PCN-20210226 TE0782-02 DDR3, EMMC Change and Product Update

Company	Trenz Electronic GmbH
PCN Number	PCN-20210226
Title	TE0782-02 DDR3, EMMC Change and Product Update
Subject	BOM change
Issue Date	2021-03-12

This change affects all Trenz Electronic TE0782 SoMs of revision 02: TE0782-02-*

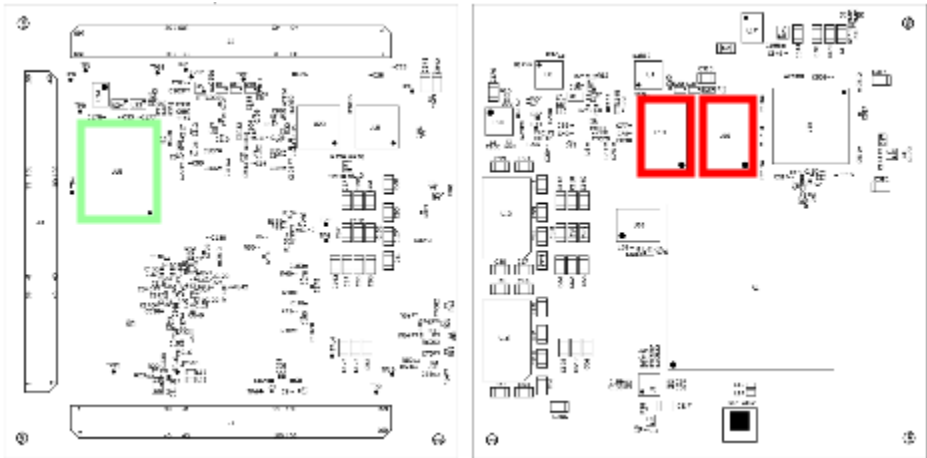
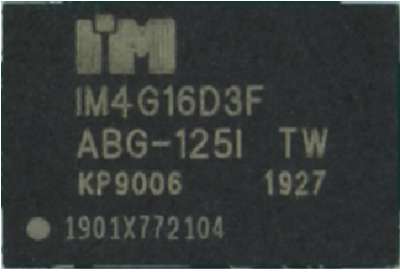
Locate DDR3 RAM (U10, U19) on bottom and eMMC (U15) on top side of PCB:

old	new
IM4G16D3FABG-125I	IS43TR16256BL-125KBLI

MTFC4GACAJCN-4M IT	IS21ES08G-JCLI
